**Colorado Springs Airport Advisory Commission Meeting
To Be Heard October 27, 2021
Land Use Review Item #12**

<p>EL PASO COUNTY BUCKSLIP NUMBER(S)/FILE NUMBER(S):</p> <p>SF2125</p> <p><i>RESIDENTIAL FINAL PLAT</i></p>	<p>PARCEL #(S):</p> <p>5408000053, 5408008002, 5408403001</p>
<p>DESCRIPTION:</p> <p>Request by Kimley-Horn on behalf of Meadowbrook Development LLC for Meadowbrook Park Filing No. 1 final plat. The plat will create 67 single-family residential lots and ten (10) tracts (Tracts A-J) for public improvements and utilities, private roads and pedestrian facilities (sidewalks), drainage, landscaping and open space uses, and future development. The property is zoned PUD/CAD-O (Planned Unit Development and Commercial Airport Overlay District) and consists of 7.8 acres. The property is located north of Highway 24.</p> <p><i>Review Note: A residential development plan for Meadowbrook Park was reviewed with recommended conditions by the Commission in December 2020.</i></p>	
<p>CONSTRUCTION/ALTERATION OF MORE THAN 1 200 FEET ABOVE GROUND LEVEL?</p> <p>No</p>	<p>DISTANCE/DIRECTION FROM COS:</p> <p>1.9 miles north of Rwy 17L</p>

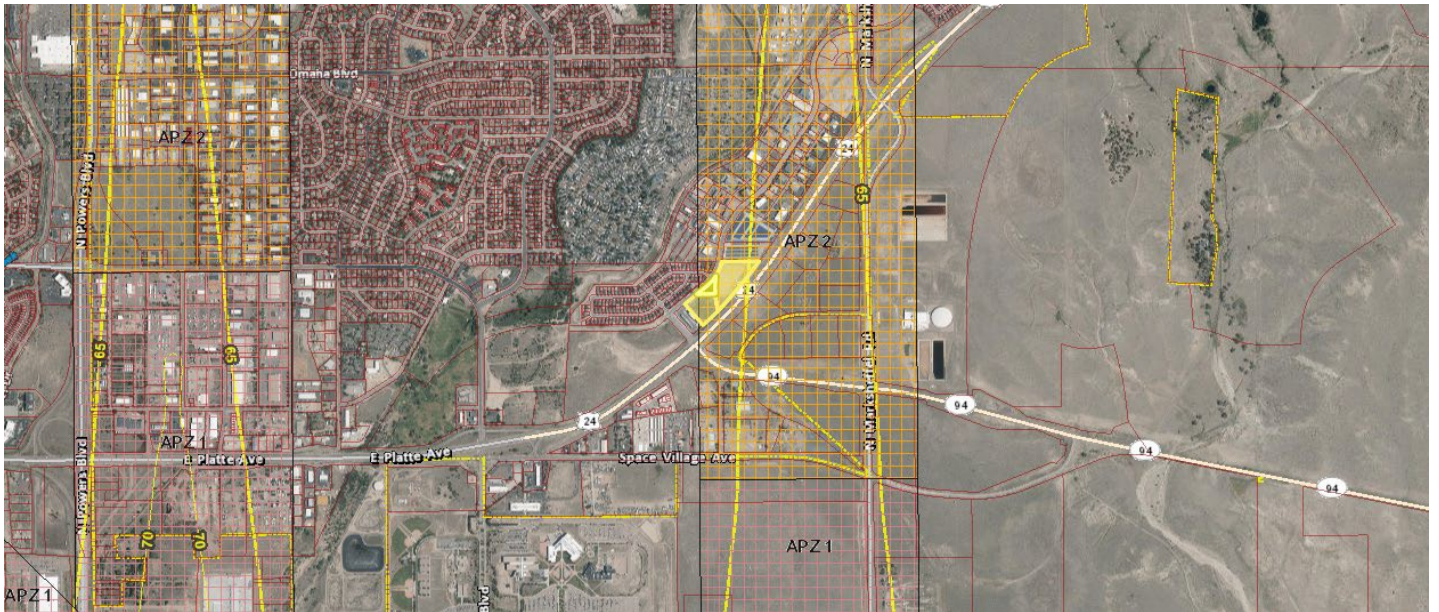
*Under current codes and regulations the Airport recognizes the proposed PUD and other residential development is outside of the current 65 DNL contour. For this reason, the Airport has **no objection** to the land use item as presented. We strongly recommend, however, that the developer consider relocation of all PUD and residential development outside the proposed 65 ASV DNL that was identified in the draft 2020 Airport Land Use Compatibility Study. The revised DNL contour has been provided to the developer.*
